Question on Eversource 10/20/23 presentation to the PAC on the A-152 and M-127 Asset Condition projects, for which Eversource chose not to provide answers though it has them all.

Pole 119: Was this photograph taken during a repair project? When was it taken?

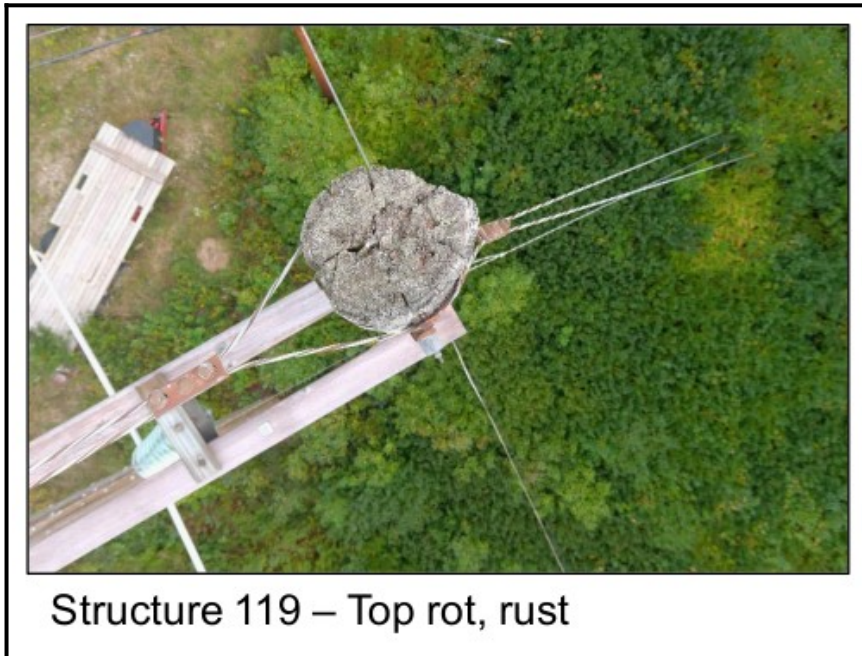
Was the rusted hardware replaced?

Is the wood on the trailer for repairs? If so, what were these repairs?

Were the crossbars and insulators replaced in 2016-17, as the glass insulators indicate?

If the crossbars and insulators were replaced, and the top rot and rust are presented as threatening system integrity, why were the rusty hardware and pole not replaced at the same time?

If the rust and uncovered-pole-top rot are not threatening system reliability, why is Eversource showing them?

If the pole top had been covered, would it be in better condition?

Pole 190: To what degree does its condition impair its function?
Is there more than one pole split?

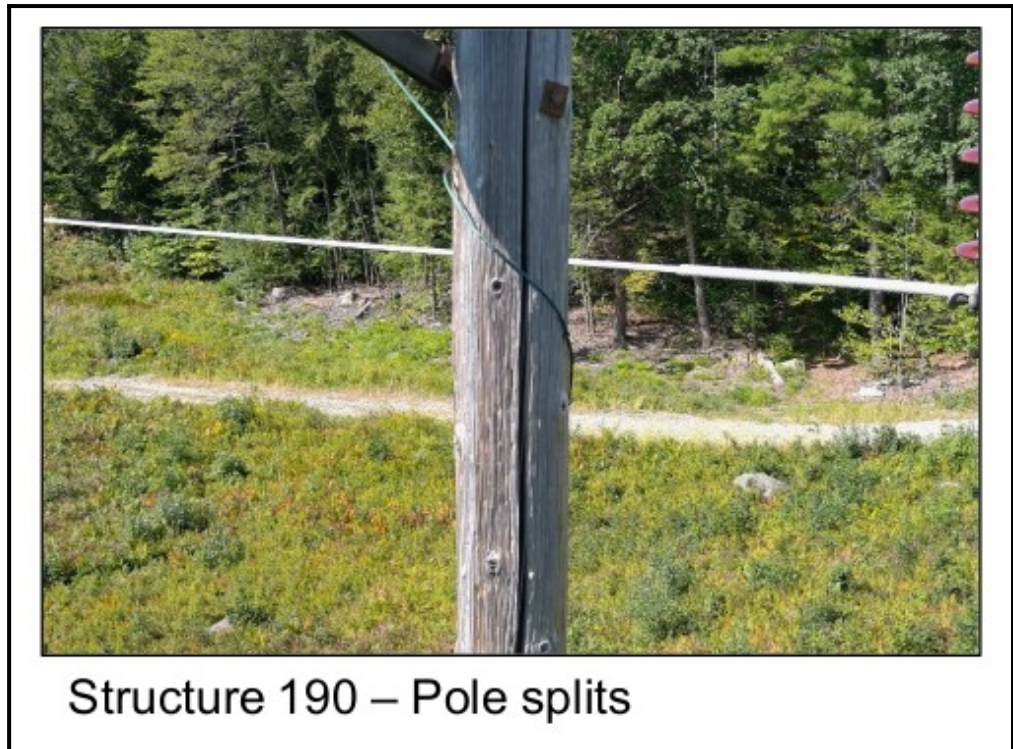
Does leaving pole tops uncovered increase the number and size of pole splits?

Is there a repair/re-inforcement procedure for pole splits?

What is the cost/benefit of repair vs. replacement?

To what degree does this pole split impair the function of the whole H-frame structure?

Pole 286: When was it last treated?

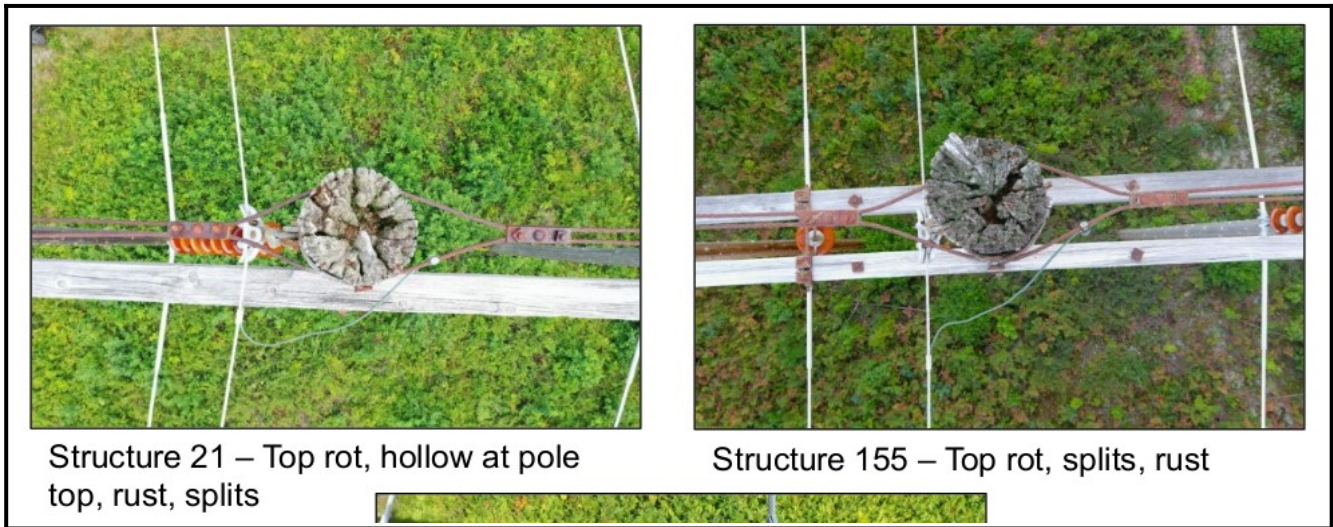
Is this White Rot (Basidiomycota with some Ascomycota), Brown Rot (Basidiomycota) or Soft Rot (Ascomycota)?

Are lichen present also?

What is the relationship between the micro-organisms causing the decay and the rate of decay?

How much does this rot affect the integrity of the

whole structure? What would this pole top look like if Eversource had covered it or protected it in another way?
